1996 Legacy Outback

1998 Forester/1997 Legacy

Shifter Rattle

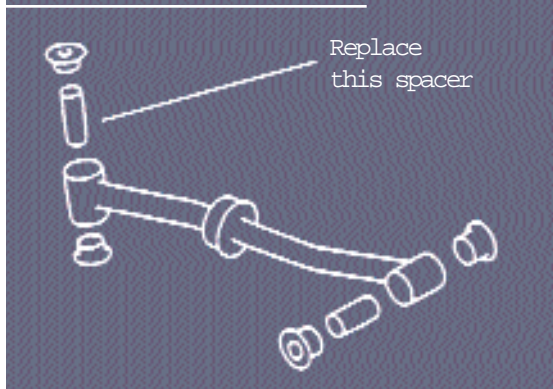
If you encounter a shifter rattle complaint on a 1996/7 Legacy Outback or a 1998 Forester, the parts to repair this problem are available through Subaru parts departments. For the 1996 Legacy Outback, order modified spacer, P/N 35045AC040. For the 1998 Forester and 1997 Legacy, order the modified bolt, P/N 35045FC000. Refer to the illustrations for installation locations.
